THE CITY OF KEY WEST
PLANNING BOARD
Staff Report

Meeting Date: September 21, 2023

Agenda Item: **Conditional Use Amendment – 114 Simonton Street (RE# 00000290-000000)** – A request for an amendment to a conditional use approval for an existing recreational rental vehicle operation, to allow for the addition of fifty (50) golf carts at a property located at 114 Simonton Street in the Historic Residential Commercial Core (HRCC-1) zoning district pursuant to Sections Sec. 18-358, 122-62(b), 122-62(c), 122-63(e), and 122-688 of the Land Development Regulations of the Code of Ordinances of the City of Key West, Florida.

Site Photos

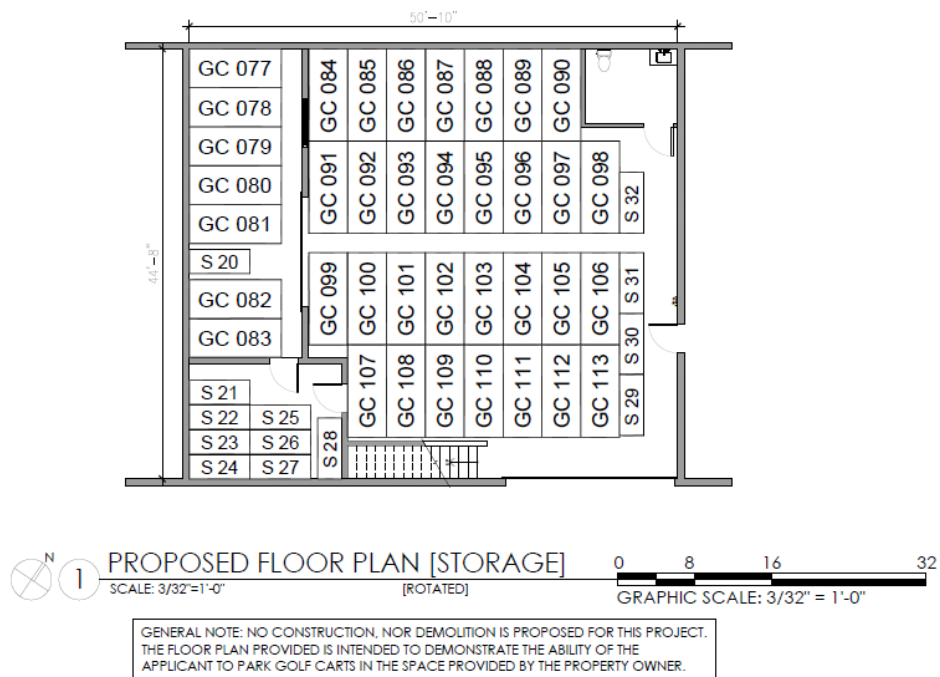
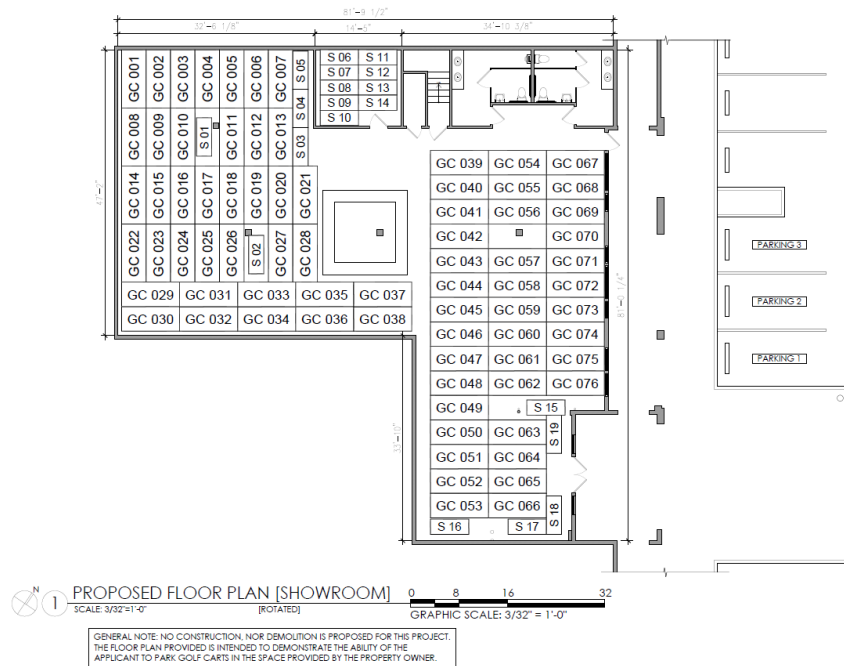
Above: Image of Simonton St & Greene Street intersection from Google Streetview. The RRV storefront is just out of the picture to the right. This image shows the site's perpendicular parking stalls which require vehicles to back into the right-of-way in order to exit. A bicyclist is seen with a child on the bicycle, passing behind a parked vehicle. The intersection is busy with bicyclists, pedestrians, and vehicles waiting and crossing at all corners. Pedestrians, bicycles, and a scooter are seen crossing the intersection at the same time, as a trolley approaches the intersection.

Below: Image facing the Simonton and Greene Streets intersection from Google Streetview. Traffic congestion is observed. The proposed storage garage and parking area are seen to the left. The site's dumpster can also be seen from the right of way; the enclosure should be modified to adequately screen the dumpster as required per Code.

- f. The existing dumpster enclosure consists of a chain link fence with opaque screening. However, the enclosure has consistently been with open gates, leaving the dumpster in full view from public streets and adjacent properties, which violates the intent of Section 108-280. Within sixty (60) days of final approval of this conditional use permit, the existing enclosure shall be adapted to ensure the gate closes properly, and the gate shall remain closed when the dumpster is not actively being used.
